Access Compliance Report

Public Rights-of-Way

(Curb Ramps)

Intersection ID: 6687	Main Street: NEVIN_RD	Cross Street: KAYRON_DR	Location: NW
ADA ID: EC65D07EE02C	Ramp Type: Directional1	Initial Pass/Fail: Fail	Overall Compliance: No
Severity Score: 25			
Codes/Mitigation Info/Possible Solution		Field Measurements/Component Compliance

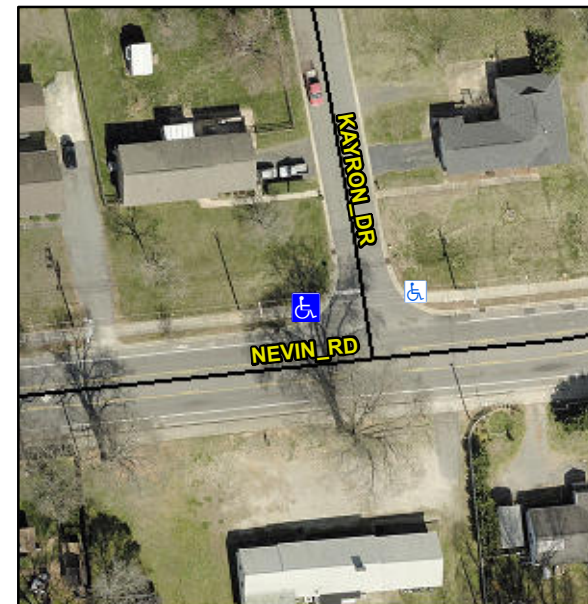
R304.5.3

Compliance	Description	Data	Compliance	Description	Data
N/A	Ramp Length (in)	27.0	N/A	Grade Break?	N/A
Yes	Ramp Width (in)	69.0	N/A	Grade Break Slope (%)	0.0
Yes	Ramp Slope (%)	7.5	N/A	Grade Break XSlope (%)	0.0
No	Ramp XSlope (%)	7.0			
N/A	Flare Type LT	N/A	N/A	Flare Type RT	N/A
N/A	Flare Slope LT (%)	N/A	N/A	Flare Slope RT (%)	0.0
N/A	Flare Traversable LT?	N/A	N/A	Flare Traversable RT?	N/A
N/A	Landing Length (in)	0.0	N/A	DWS Provided?	N/A
N/A	Landing Width (in)	0.0	N/A	DWS Contrast?	N/A
N/A	Landing Slope (%)	0.0	N/A	DWS Length (in)	N/A
N/A	Landing X Slope (%)	0.0	N/A	DWS Full Width?	N/A
N/A	Landing Curb? (Y/N)	N/A	N/A	DWS Offset LT (in)	N/A
N/A	Shared Landing?	N/A	N/A	DWS Offset RT (in)	N/A
N/A	Gutter Ponding?	0.0	N/A	Gutter Slope (%)	N/A
N/A	Gutter Lip Ht (in)	0.0	N/A	Gutter X Slope (%)	N/A
N/A	Painted X Walk1?	No		Road Slope (%)	4.0
	X Walk 1 Direction	To E		Road X Slope (%)	8.4
	X Walk 1 Width (in)	N/A		Clear Space?	N/A

X Walk 1 Slope (%)	4.0	N/A	Clear Space to XWalk (in)	N/A
	X Walk 1 X Slope (%)	8.4	N/A	Storm Grate/Utility Hazard?	N/A
N/A	Ramp inside XWalk1?	N/A		Storm Grate/Utility Type	
N/A	Any Obstructions?	N/A			N/A
	Obstruction Type		Yes	Surface Condition? (G/P)	Good
			N/A	Curb Slope (%)	14.6

Remove & Replace Entire Ramp.
